UNITED STATES PATENT AND TRADEMARK OFFICE

10/707,134

Office Action Summary	Application No. 10/707,134	Applicant(s) MARX, MICHAEL	
	Examiner Philip Gabler	Art Unit 3637

Morghen '588 Figures 1-3

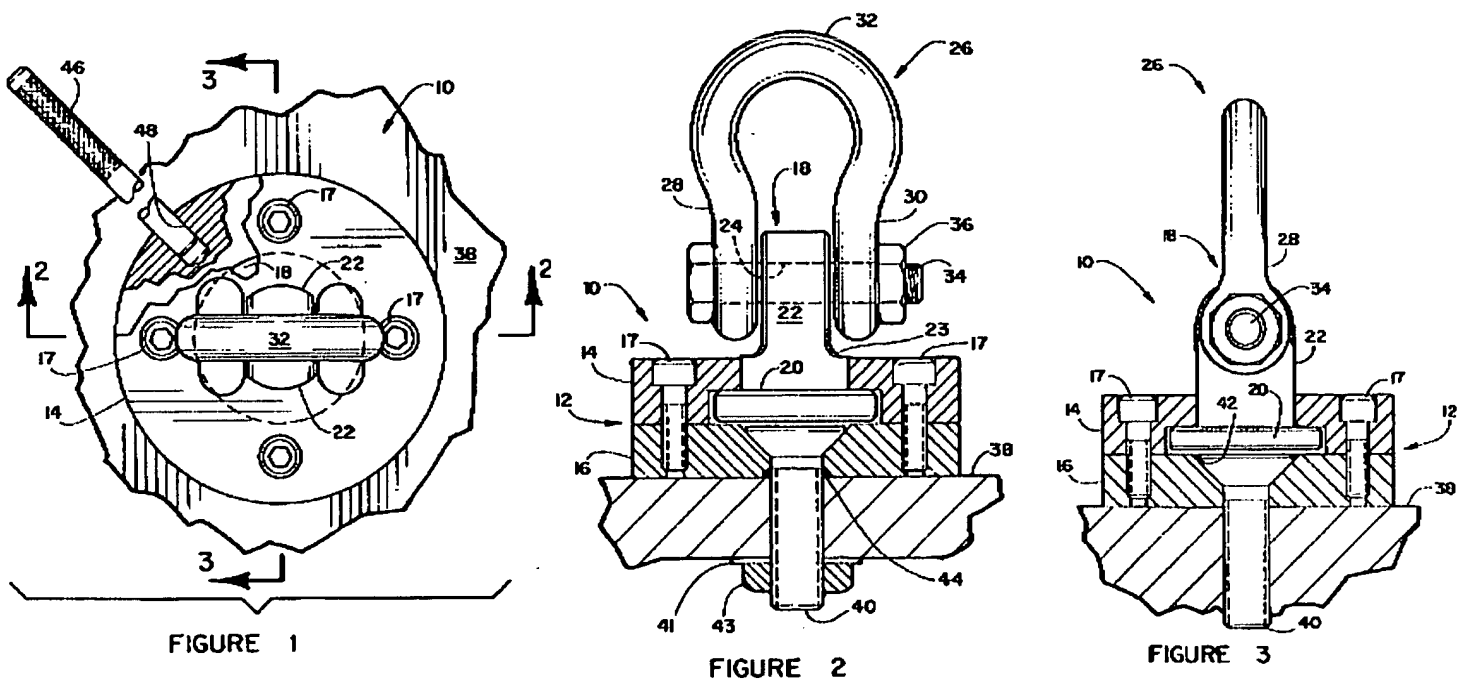
8. Claims 2-22 and 25-35 are rejected under 35 U.S.C. 102(b) as being anticipated by Morghen (US Patent Number 5823588).

9. Regarding claim 3, Morghen (Figures 1-3) discloses an anchor device (10) for coupling an external device to a surface of a deck (38), said anchor device being received within an opening (through which element 40 passes) of the surface, said opening having an edge of the surface therein, said anchor device comprising: an anchor body (12, including 26, 40, 43, etc.) having a longitudinal side (Figure 2) and a lateral side (Figure 3), said anchor body positioned at least partially within said opening so that a notch (viewed as the notch formed by 16, 40 and 41) formed in the lateral side receives the edge of the surface, said anchor body comprising a coupler (22, 26) extending outward from the opening, said coupler capable of coupling to an external device. [While a specific external device is not disclosed, such a device (e.g. a hook) is inherent in the operation of the invention.]

10. Regarding claim 2, Morghen further discloses the notch comprises a generally U-shape notch (see figures).

11. Regarding claim 4, Morghen further discloses the coupler comprises a first coupler (22) and a second coupler (26).

12. Regarding claim 5, Morghen further discloses said first coupler and said second couple have a respective first coupling hole (24) and a second coupling hole (aperture of 28) therethrough.

14. Regarding claim 7, Morghen further discloses the anchor body comprises a first body portion (14, 18, etc.) and a second body portion (16, 40, etc.), said first body portion having the coupler and said second body comprising said notch.

15. Regarding claims 9 and 10, Morghen further discloses the second body portion is fixedly coupled to the first body portion (via elements 17) forming a unitary structure.

16. Regarding claim 11, Morghen further discloses the first body portion has a first planar member (14) extending parallel to said surface, said coupler extending in a direction perpendicular to said first planar member.

17. Regarding claims 13 and 14, Morghen further discloses said first body portion further comprises an extension portion (17) having a circular shape, said extension portion extending into said second body portion.

18. Regarding claim 15, Morghen further discloses said second body portion comprises a second planar member (16) coupled to said first body portion.

19. Regarding claims 17-19, Morghen further discloses the second planar member has a first length (in the longitudinal direction) greater than an opening length and a first width (in the lateral direction) greater than an opening width (the opening length and width being the equivalent, longitudinal and lateral, measures of the opening).

20. Regarding claim 21, Morghen further discloses the second body portion comprises a channel (through which 17 passes) therethrough for receiving a fastener (17), said fastener coupling said first body portion and said second body portion.

21. Regarding claim 22, Morghen further discloses a fastener plate (41) coupled to the second body portion.

22. Regarding claims 8, 12, 16, and 20, Morghen discloses an anchor device (10) for coupling an external device to a surface of a deck (38), said anchor device being received within an opening (through which element 40 passes) of the surface, said opening having an edge of the surface therein, said anchor device comprising: an anchor body (12, including 26, 40, 43, etc.) comprising a first body portion (16, 40, etc.) and a second body portion (14, 18, etc.), said anchor body positioned at least partially within said opening so that a notch (viewed as the notch formed by 16, 40 and 41) in the first body portion receives the edge of the surface, said second body portion comprising a coupler (22, 26) extending outward from the opening, said coupler capable of coupling to an external device, the first body portion having a first planar member (16) extending parallel to said surface, said coupler extending in a direction perpendicular to said first planar member, said anchor body having a flange (20) coupled to said first planar member (via the second body portion) and said coupler, the second body portion being rotatably coupled to the first body portion (in that by removing fasteners 17, the second body portion could be rotated in increments of 90°) and having a second planar member (14) disposed parallel to the surface, coupled to the first planar member, and sized

23. Regarding claims 26 and 27, Morghen discloses an anchor device (10) for coupling an external device to a surface of a deck (38), said anchor device being received within an opening (through which element 40 passes) of the surface, said opening having an edge of the surface therein, said anchor device comprising: a first body portion (16, 40, etc.) having a longitudinal side (Figure 2) and a lateral side (Figure 3), said first body portion positioned at least partially within said opening so that a notch (viewed as the notch formed by 16, 40 and 41) formed in the lateral side receives the edge of the surface and partially positioned on said surface over said opening and a first member (16) positioned over the opening to engage a top surface of the deck; and a second body portion (14, 18, etc.), having a coupler (22, 26) extending outward from the first body portion, said coupler capable of coupling to an external device, the second body portion being rotatably coupled to the first body portion (in that by removing fasteners 17, the second body portion could be rotated in increments of 90°). [Note that while a specific external device is not disclosed, such a device (e.g. a hook) is inherent in the operation of the invention.]

24. Regarding claim 25, Morghen further discloses the notch comprises a generally U-shape notch (see figures).

25. Regarding claims 28 and 29, Morghen further discloses the second body portion is fixedly coupled to the first body portion (via elements 17) forming a unitary structure.

26. Regarding claim 30, Morghen further discloses a flange (20) coupled to said first body member (via the second body portion) and said coupler.

27. Regarding claims 31 and 32, Morghen further discloses said first body portion further comprises an extension portion (17) having a circular shape, said extension portion extending into said second body portion.

28. Regarding claims 33 and 34, Morghen further discloses said second body portion comprises a second planar member (14) coupled to said first body portion and sized greater than said opening.

29. Regarding claim 35, Morghen further discloses the second body portion comprises a channel (through which 17 passes) therethrough for receiving a fastener (17), said fastener coupling said first body portion and said second body portion.

Celette '236 Figures 1, 2, and 4

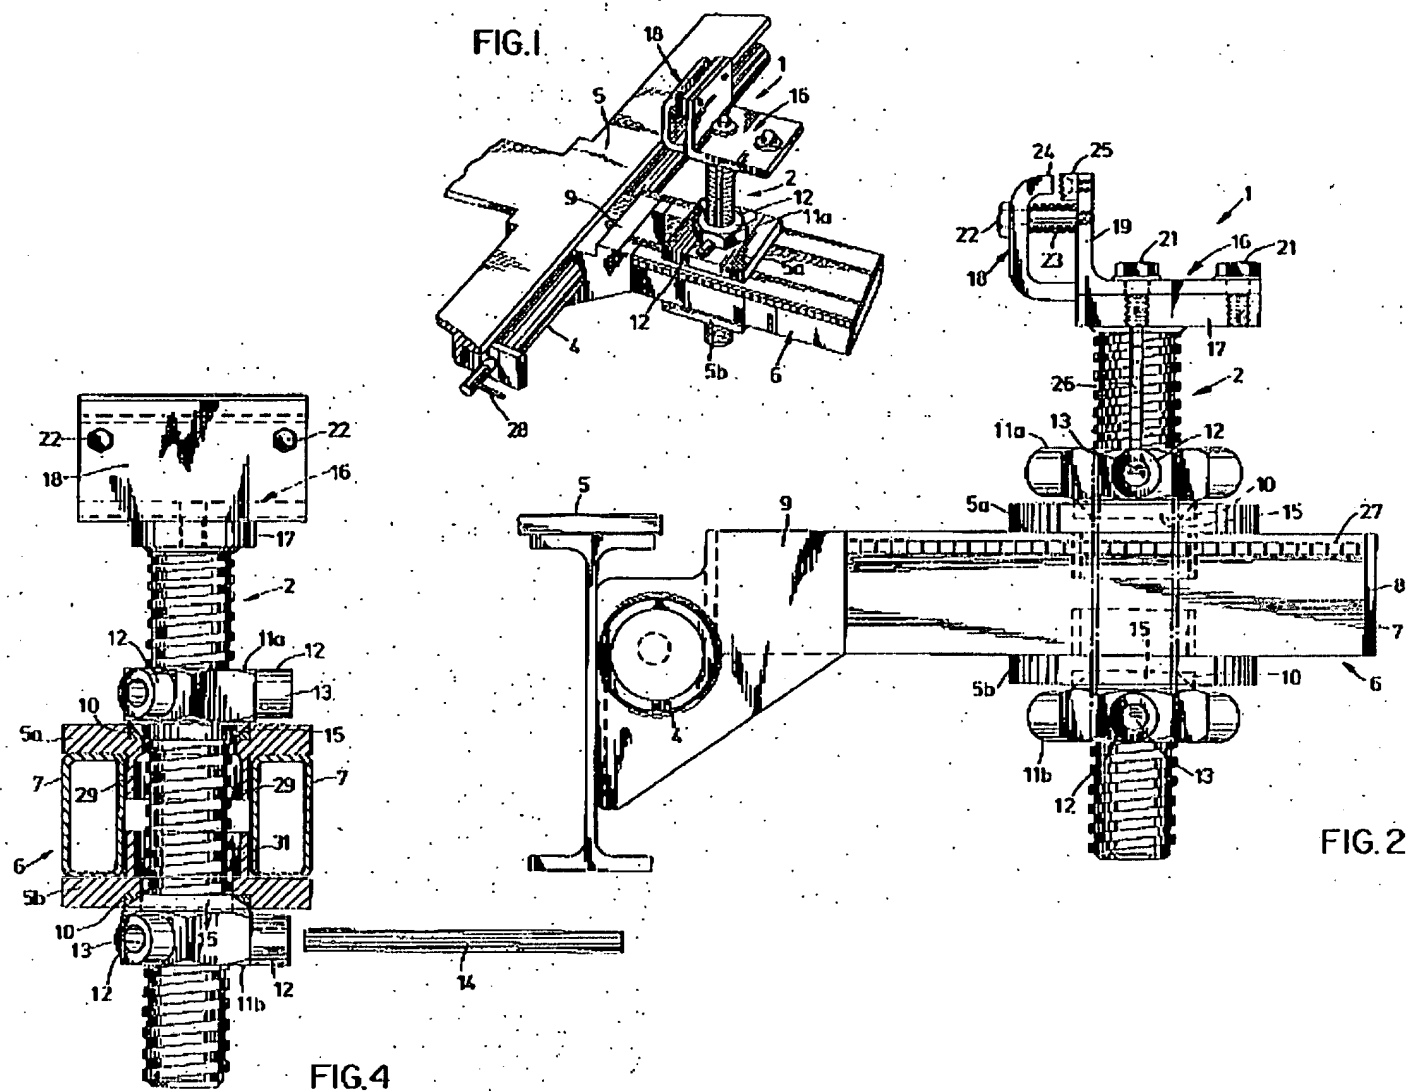
30. Claims 2-18, 20-23, and 25-35 are rejected under 35 U.S.C. 102(b) as being anticipated by Celette (US Patent Number 4519236).

31. Regarding claim 3, Celette (Figures 1, 2, and 4) discloses an anchor device (1, 2, 5, 14, etc.) for coupling an external device to a surface of a deck (6), said anchor device being received within an opening (between elements 7 of 6) of the surface, said opening having an edge of the surface therein, said anchor device comprising: an anchor body (1, 2, 5, including 16, etc.) having a longitudinal side (on left of Figure 1) and a lateral side (side seen in Figure 2), said anchor body positioned at least partially within said opening so that a notch (viewed as the notch formed by elements 5a and 5b) formed in the lateral side receives the edge of the surface, said anchor body comprising a coupler (formed by 16 and 18) extending outward from the opening, said coupler capable of coupling to an external device (for instance a vehicle body, not shown, but described in column 3 lines 16-21).

32. Regarding claim 2, Cellette further discloses the notch comprises a generally U-shape notch (see figures).

33. Regarding claim 4, Celette further discloses the coupler comprises a first coupler (19 of 16) and a second coupler (18).

34. Regarding claim 5, Celette further discloses said first coupler and said second couple have a respective first coupling hole (in 19 for bolt 22) and a second coupling hole (in 18 for bolt 22) therethrough.

36. Regarding claim 7, Celette further discloses the anchor body comprises a first body portion (1) and a second body portion (5a, 5b, etc.), said first body portion having the coupler and said second body comprising said notch.

37. Regarding claims 9 and 10, Celette further discloses the second body portion is fixedly coupled to the first body portion (via screw element 2) forming a unitary structure.

38. Regarding claim 11, Celette further discloses the first body portion has a first planar member (horizontal member of 16) extending parallel to said surface, said coupler extending in a direction perpendicular to said first planar member.

39. Regarding claims 13 and 14, Celette further discloses said first body portion further comprises an extension portion (2) having a circular shape, said extension portion extending into said second body portion.

40. Regarding claim 15, Celette further discloses said second body portion comprises a second planar member (horizontal member of 5a) coupled to said first body portion.

41. Regarding claims 17 and 18, Celette further discloses the second planar member has a first length or width (in the longitudinal direction) greater than an opening length or width (the opening length or width being the equivalent measure of the opening).

42. Regarding claim 21, Celette further discloses the second body portion comprises a channel (through which 2 passes) therethrough for receiving a fastener (2), said fastener coupling said first body portion and said second body portion.

43. Regarding claim 22, Celette further discloses a fastener plate (11a) coupled to the second body portion.

44. Regarding claims 8, 12, 16, and 20, Celette discloses an anchor device (1, 2, 5, etc.) for coupling an external device to a surface of a deck (6), said anchor device being received within an opening (between elements 7 of 6) of the surface, said opening having an edge of the surface therein, said anchor device comprising: an anchor body (1, 2, 5, including 16, etc.) comprising a first body portion (5a, 5b, etc.) and a second body portion (1), said anchor body positioned at least partially within said opening so that a notch (viewed as the notch formed by elements 5a and 5b) in the first body portion receives the edge of the surface, said second body portion comprising a coupler (formed by 16 and 18) extending outward from the opening, said coupler capable of coupling to an external device, the first body portion having a first planar member (horizontal member of 5a) extending parallel to said surface, said coupler extending in a direction perpendicular to said first planar member, said anchor body having a flange (17) coupled to said first planar member (via element 2) and said coupler, the second body portion being rotatably coupled to the first body portion and having a second planar member (horizontal member of 16) disposed parallel to the surface, coupled to the first planar member (via element 2), and sized greater than said opening (at least in one dimension). [Note that while a specific external device is not shown, a vehicle body is described in column 3 lines 16-21 as being engaged by the coupler.]

an opening (between elements 7 of 6) of the surface, said opening having an edge of the surface therein, said anchor device comprising: an anchor body (1, 2, 5, including 16, etc.) positioned at least partially within said opening so that a notch (viewed as the notch formed by elements 5a and 5b) receives the edge of the surface, said anchor body comprising a coupler (formed by 16 and 18) extending outward from the opening, said coupler capable of coupling to an external device, said coupler being trapezoidally-shaped (elements 18 and 19 both have trapezoidal shape, see Figure 4). [Note that while a specific external device is not shown, a vehicle body is described in column 3 lines 16-21 as being engaged by the coupler.]

46. Regarding claims 26 and 27, Celette discloses an anchor device (1, 2, 5, etc.) for coupling an external device to a surface of a deck (6), said anchor device being received within an opening (between elements 7 of 6) of the surface, said opening having an edge of the surface therein, said anchor device comprising: a first body portion (5a, 5b, etc.) having a longitudinal side (on left of Figure 1) and a lateral side (side seen in Figure 2), said first body portion positioned at least partially within said opening so that a notch (viewed as the notch formed by elements 5a and 5b) formed in the lateral side receives the edge of the surface and partially positioned on said surface over said opening and a first member (horizontal member of 5a) positioned over the opening to engage a top surface of the deck; and a second body portion (1), having a coupler (formed by 16 and 18) extending outward from the first body portion, said coupler capable of coupling to an external device, the second body portion being rotatably coupled to the first body portion. [Note that while a specific external device is

47. Regarding claim 25, Celette further discloses the notch comprises a generally U-shape notch (see figures).

48. Regarding claims 28 and 29, Celette further discloses the second body portion is fixedly coupled to the first body portion (via screw element 2) forming a unitary structure.

49. Regarding claim 30, Celette further discloses a flange (17) coupled to said first body member (via element 2) and said coupler.

50. Regarding claims 31 and 32, Celette further discloses said first body portion further comprises an extension portion (2) having a circular shape, said extension portion extending into said second body portion.

51. Regarding claims 33 and 34, Celette further discloses said second body portion comprises a second planar member (horizontal member of 16) coupled to said first body portion (via element 2) and sized greater than said opening (at least in one dimension).

52. Regarding claim 35, Celette further discloses the second body portion comprises a channel (through which 21 passes) therethrough for receiving a fastener (21), said fastener coupling said first body portion and said second body portion (via element 2).
